Report to the Plan Commission

March 7, 2011

640 North Henry Street

Conditional Use Alteration Request

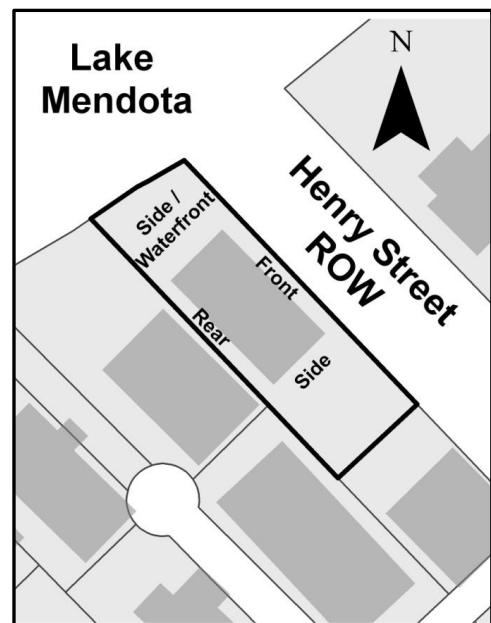
For reference, it is worth noting that the yards for this unique lot are rigidly defined by its frontage on North Henry Street. As shown to the right, the east side of the property along the North Henry Street right-of-way is officially the front yard, even while it appears as though it would be a side yard due to the lot dimensions and orientation of the building. Because of the yard requirements in Downtown Design Zone 2, the yard definition essentially prohibits a property owner from seeking PUD Zoning for this lot, since the yard requirements would be impossible to meet. With a full understanding of this limitation, the applicant is seeking a conditional use in the R6 District, which also necessitated review and approval by the Zoning Board of Appeals for variances.
